Project Management Office: PMO-  
FRERMIP  
Flood and Riverbank Erosion Risk  
Management Investment Program  
Pani Bhaban, Level-10, Block B & D  
72 Green Road, Dhaka-1205.  
Tel: + 880222230242  
E-mail: [pdjmrem@gmail.com](mailto:pdjmrem@gmail.com)

**REPORT OF THE TECHNICAL COMMITTEE IN C/W FRERMIP-2**

A Technical Committee for “Flood and Riverbank Erosion Risk Management Investment Program (Project-2) were formed (as stipulated in the DPP) as per approval of Director General, BWDB, Dhaka. **(Annexure-A)**

The 1<sup>st</sup> meeting of the Technical Committee was held on 19 February 2023, chaired by Muhammad Amirul Haq Bhuiya, Additional Director General (Planning, Design and Research), BWDB, Dhaka. The decisions of the meeting are as follows: **(Annexure-B: Minutes of the Meeting)**.

Figure 1 W01 site condition

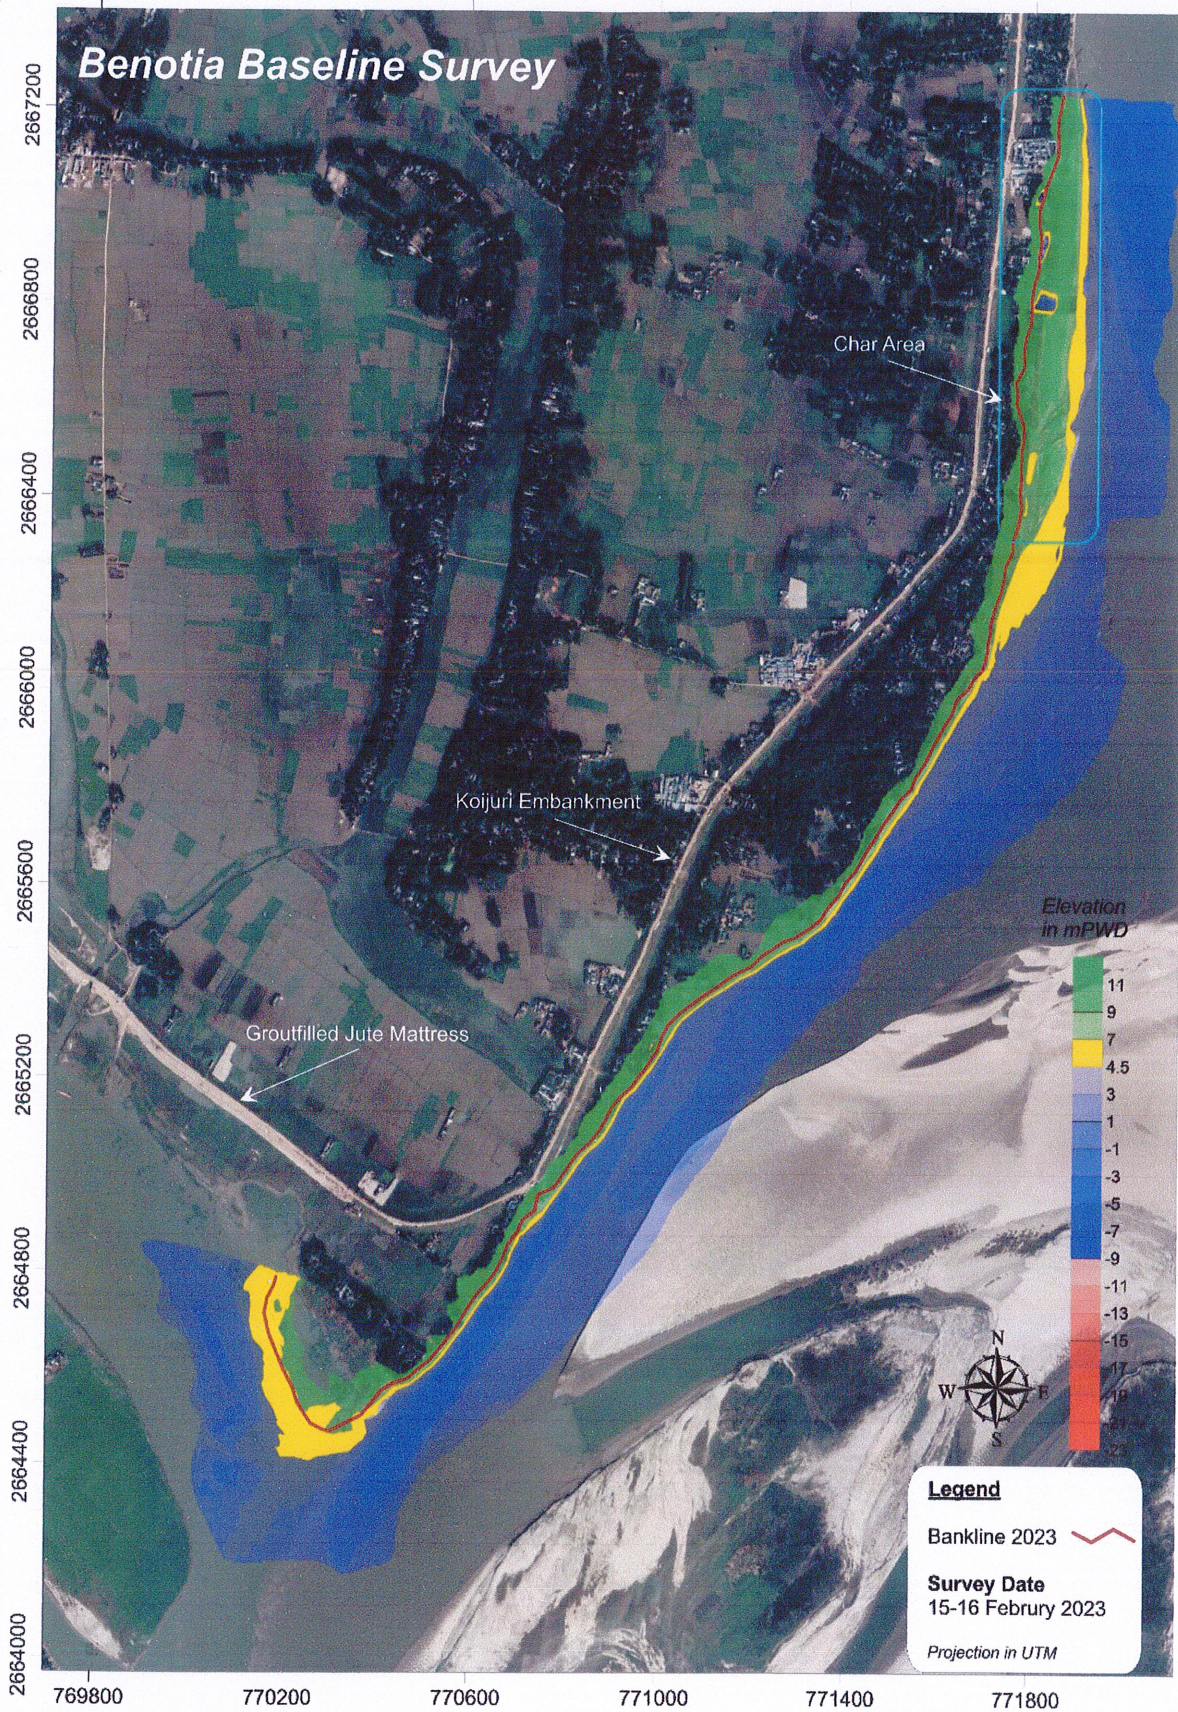
The committee visited the upstream end of the works, which ties into the existing Kajjuri revetment. There is an approximately 700 m long char (Figure 2). The committee discussed to provide the protection along the existing char.

- (i) The char is protected in places through emergency works and likely to eroded.
- (ii) The char is high, reaching floodplain level.
- (iii) The char overlaps some 200 m with the downstream end of the Kajjuri works.
- (iv) There are a number of houses along the bankline in the old alignment of the works, requiring quite intensive resettlement activities.
- (v) The char extends the safety margin to the constructed embankment (FRERMIP Project-1).
- (vi) The existing ditches of this char land needs to fill-up.

05. The high char along the original bank line will be included into the ongoing protection of W-01. Also, the ditches /low lying areas to be filled up. The downstream 200/300m of the protection work will be placed alongside the sand deposited by BIWTA dredging activities at the left bank along the out-fall of Hurasagor maintaining the river boundary.
